SERVICE BULLETIN

APPLICABILITY: 2012-14MY Impreza and XV Crosstrek Models **NUMBER:** 12-182-15
 2015MY WRX and STI Models **DATE:** 03-30-15

SUBJECT: New Front Door Checker Mechanism

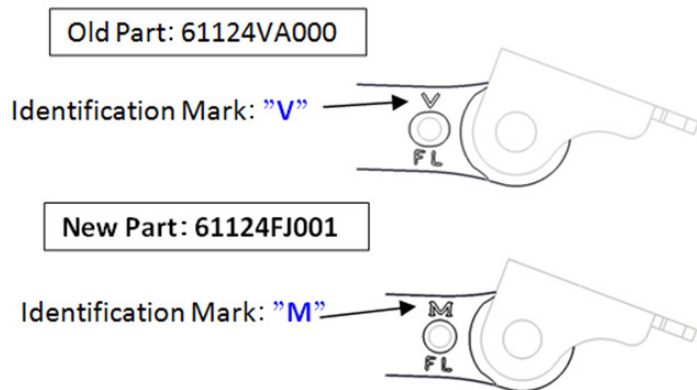
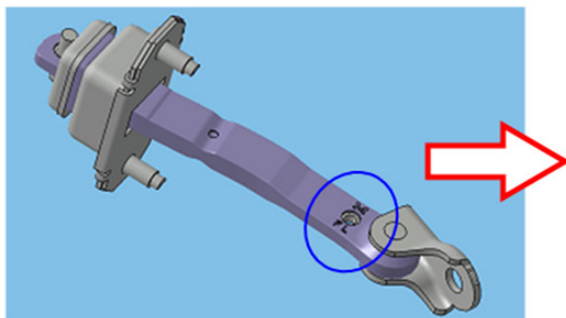
This bulletin announces availability of a revised front door checker mechanism designed to hold the front doors more securely when they are in partially open positions. An additional detent position has also been added.

DESCRIPTION	NEW PART NUMBER	OLD PART NUMBERS
CHECKER ASSY DR F	61124FJ001	61124FJ000 and 61124VA000

NOTE: Replace the checkers on both front doors at the same time following the replacement procedure in the applicable Service Manual.
